GREAT LAKES INDIAN FISH AND WILDLIFE COMMISSION

October 20, 2015

Re: Discharge from PolyMet east pit at closure greater than previously reported

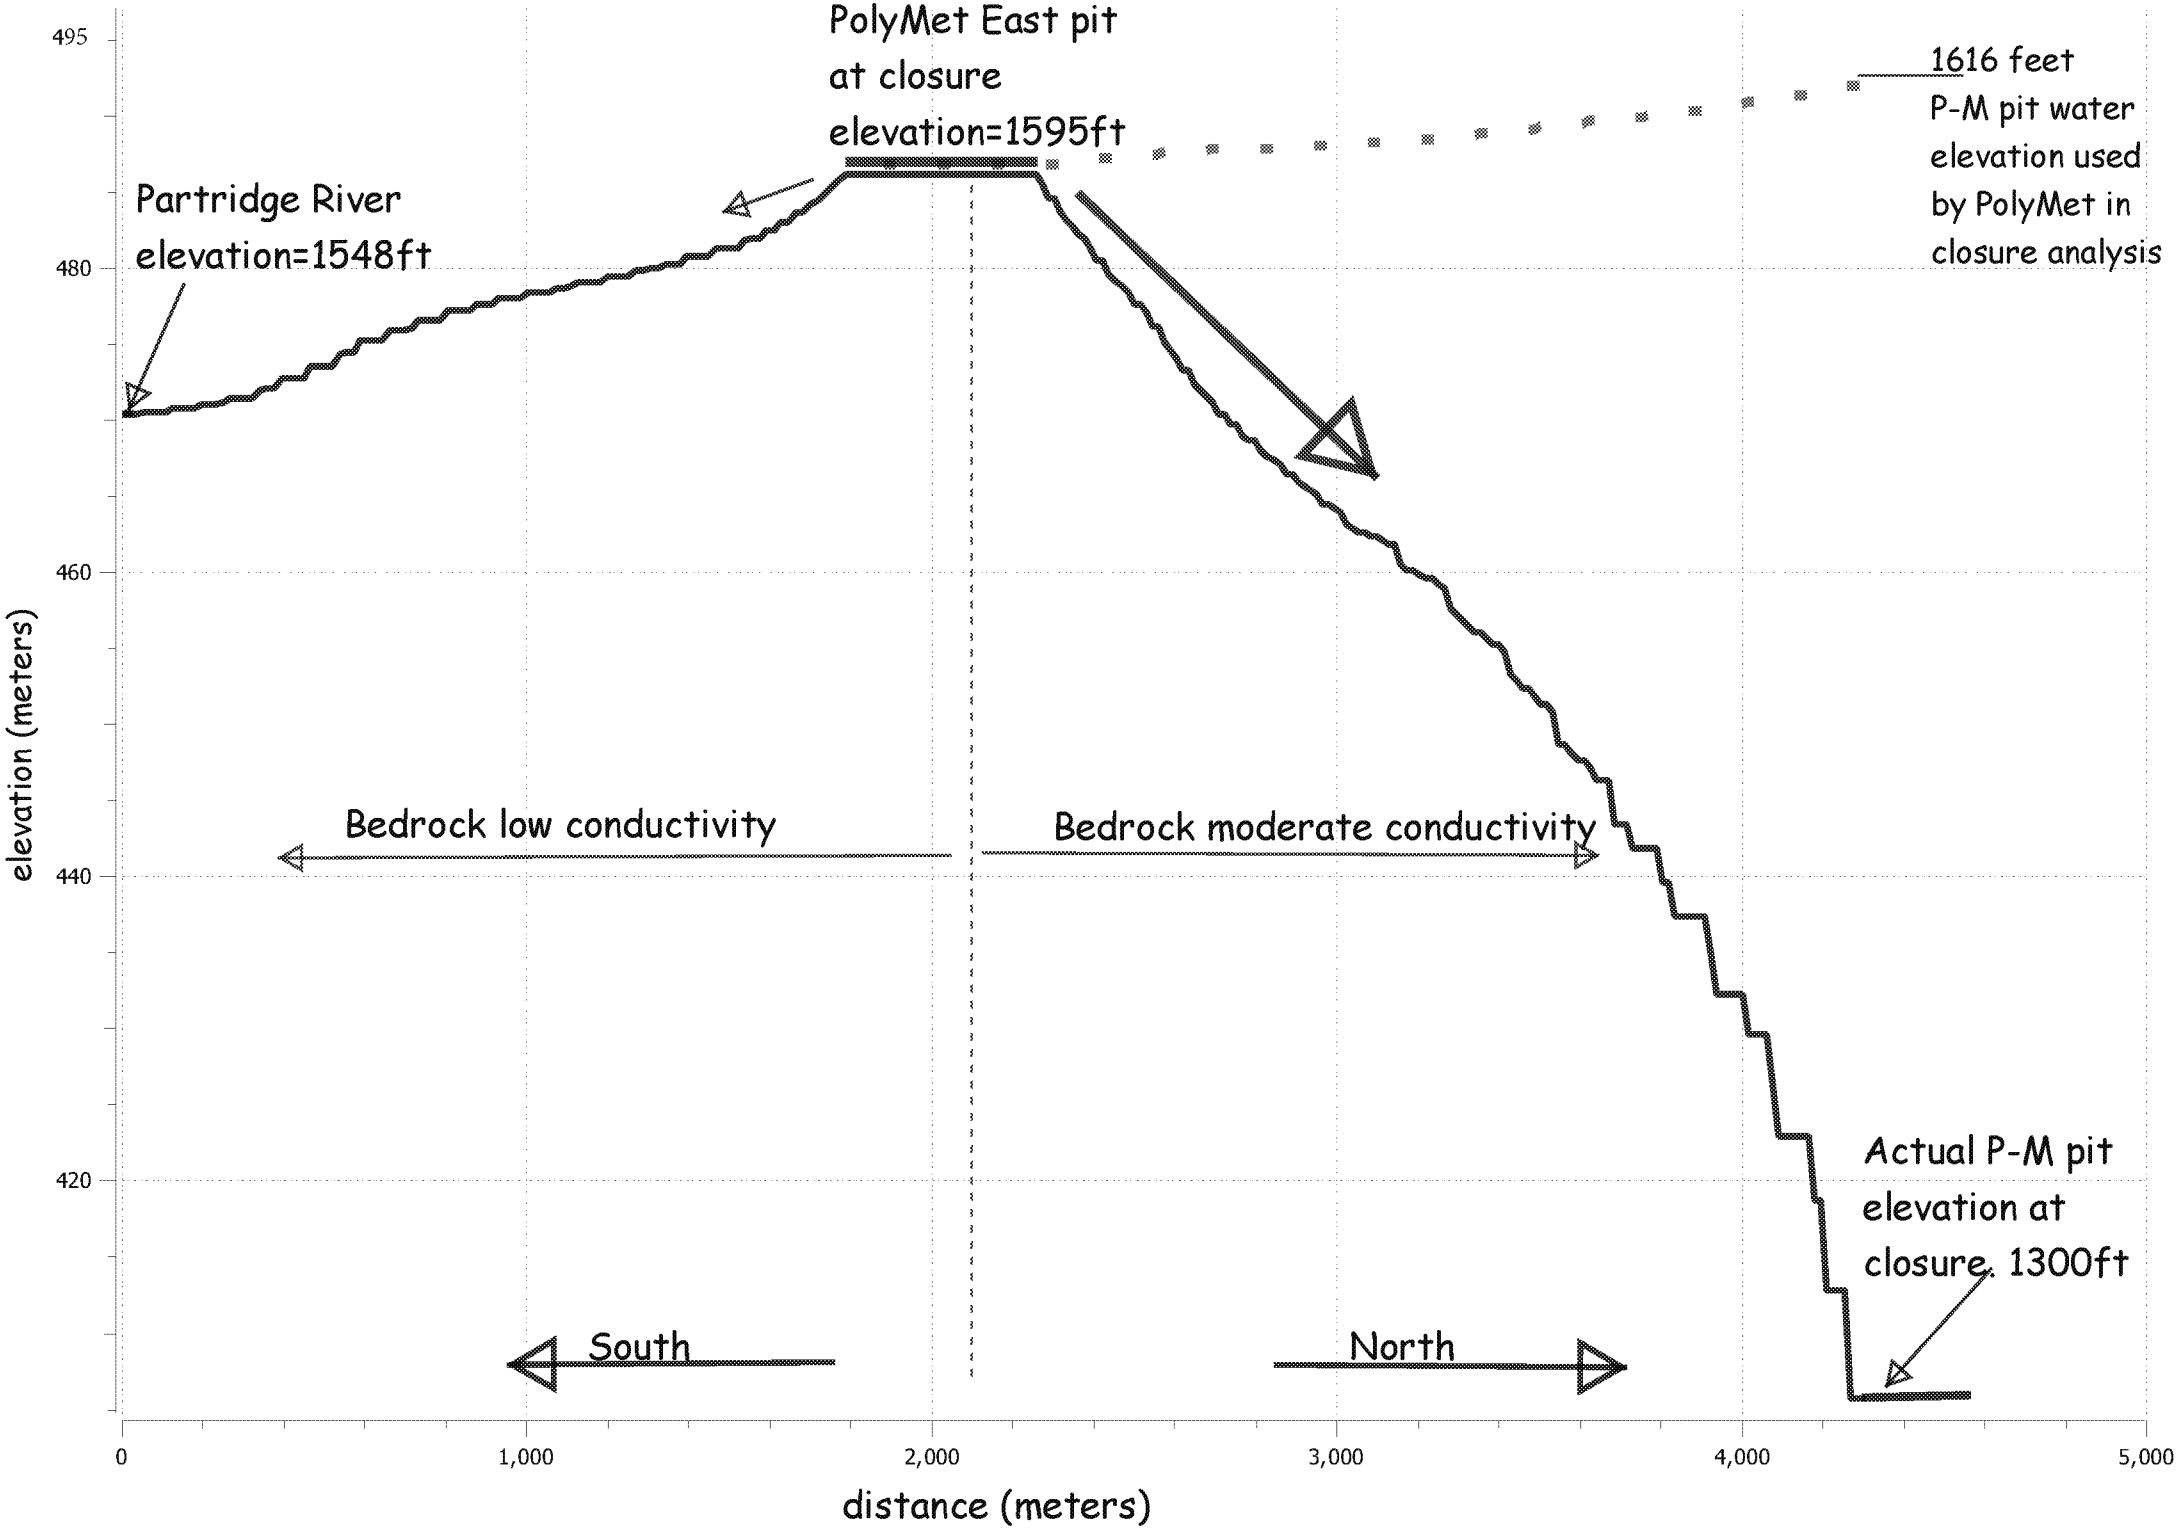
Flow direction is not the only factor affected by correctly implementing the P-M pit water elevations at closure. The volume of water leaving the PolyMet east pit is significantly greater if correct P-M pit water elevations are considered.

Both common sense (strong gradient to the north and more conductive bedrock to the north) and modeling, suggest that a substantial portion of the contaminants leaving the PolyMet east pit will move north in the post-closure period (see attached figure). Please note that because the mine pits are both deeply excavated into the bedrock but natural lakes are generally underlain with a lakebed, arguments related to the presence of Argo or other pit-side lakes are not hydrologically relevant to this issue; The connection between the PolyMet pits and the P-M pits is primarily through the relatively high conductivity Virginia Formation and Biwabik Iron Formation bedrock.

Our recent water budget analysis using the USGS utility ZoneBudget indicates that approximately 90% of the water leaving the 1595 foot elevation PolyMet east pit will travel north in bedrock toward the Peter-Mitchel pits when the P-M pits are at their correct closure elevation (1300 feet). Because of the 295 foot greater head pressure of the closed PolyMet east pit compared to the P-M pits and the relatively high conductivity of the Virginia and Biwabik Iron bedrock formations, it is not surprising that the majority of water leaving the PolyMet east pit would flow north.

Preliminary water budget analysis indicates that approximately 300 gpm will exit the PolyMet east pit through bedrock post-closure, when the P-M pits are at 1300 feet. This is in contrast to the total of 10 gpm that Barr Engineering estimated using the same mine pit inflow/outflow model but with P-M pit water elevations that were 316 feet too high (see attached figure). Contaminant transport analysis that accounts for approximately 300 gpm rather than 10 gpm of east pit groundwater discharge is likely to generate different conclusions for water quality at points of compliance.
